Specific Design Plan SDP-2201

National Capital Business Park, Parcel 12

STAFF REPORT

SUBJECT: Specific Design Plan SDP-2201
 Type 2 Tree Conservation Plan TCP2-026-2021-04
 National Capital Business Park, Parcel 12

Figure 1: Illustrative Site Plan

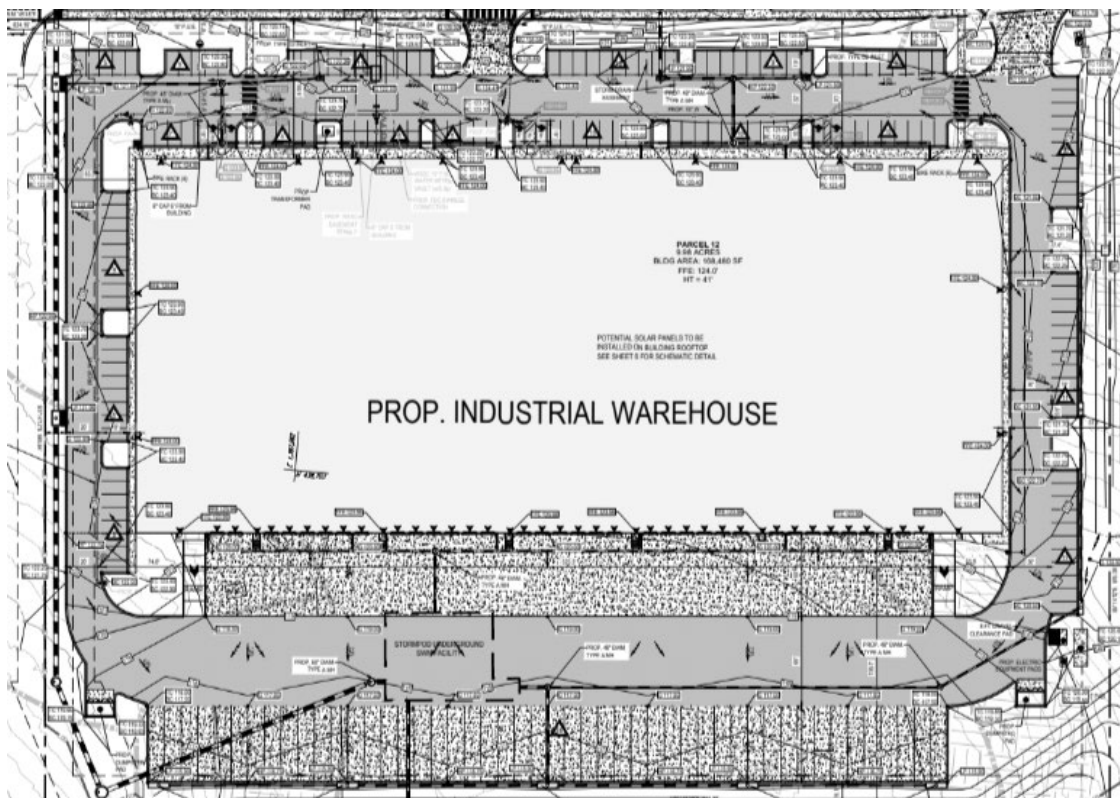
- a. Provide building dimensions on Sheet 5.
 - b. Provide the detail for the trash enclosures.
 - c. Show the setbacks of the entrance sign on Sheet 5.

- d. Dimension the proposed electrical equipment pads on Sheet 5 and provide the detail for the equipment, cabinets, or pads.
 - e. Identify the type and location of the loading doors on Sheet 5.

- f. Add all sign details for approval with the SDP, or a revision to the SDP will be required prior to approval of any sign permit applications.
 - g. Provide an alternative/lighter shading for the proposed concrete shown on the site plan, as the current shading identifier obscures parking, notes, and site plan elements, which will only get worse as the plan is copied and submitted for future permit applications.
